Re: DA 2020/702/1

**16 Old Hume Highway, 40 and 42 Macquarie Avenue
Camden**

Demolition of existing structures, tree removal, lot consolidation and construction of a multi-dwelling housing development comprising of 22 units across 3 storeys, basement car parking, stormwater drainage works, landscaping, servicing and associated site works

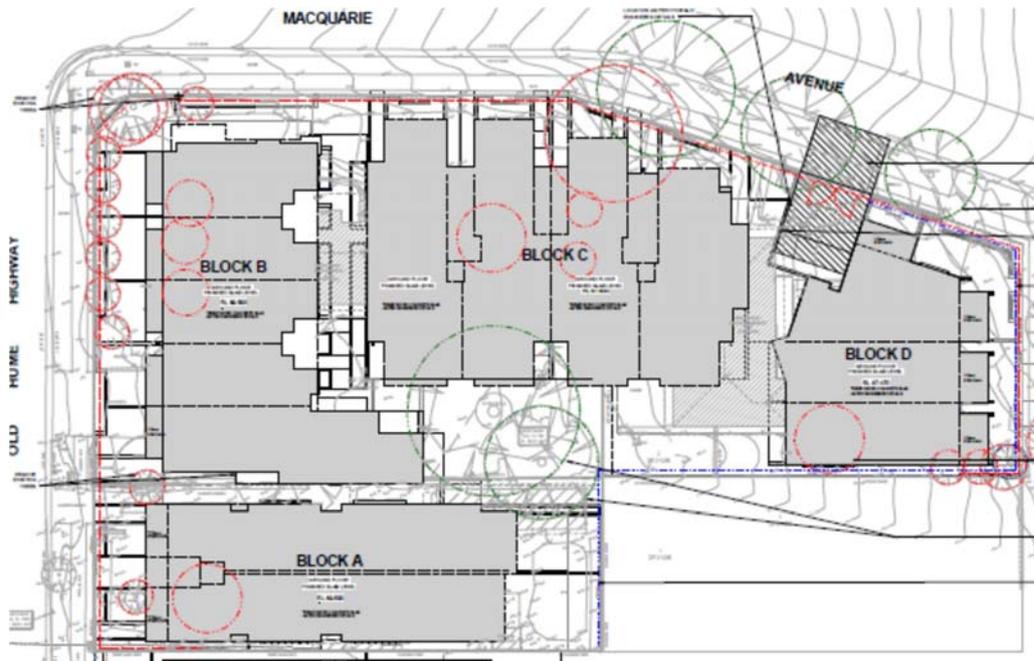
The above artist's impression particularly demonstrates that the proposed development does not comply with image and legibility requirements of DCP 4.6.

It is not in keeping with the character of the area and streetscape and presents as a grey monolith, contemptuous of its older neighbours, with little separation between dwelling units. The design, proportions, colours, materials and massing are extremely incompatible with the streetscape and older Camden in general and are disruptive to the sense of place.

This section of the development also presents as three-storey, in an area that is largely single storey, or at most two- storey.

The proposed three-storeys contravenes DCP 4.2.5.

DCP 4.6 site requirements include minimum setbacks. Our calculations indicate that the setbacks do not allow for protruding verandas on the Old Hume Highway and for porches on the Macquarie Avenue frontage.

Also, the DCP side setback requirement is 4.0m minimum for a second storey. It would appear that the proposed buildings do not comply with this. No side setback requirement is specified for the third storey as this is not meant to exist.

The proposed buildings do not seem to be compliant with the set-back requirements. This has ramifications for neighbourhood amenity and privacy. We request that the setbacks be carefully checked.
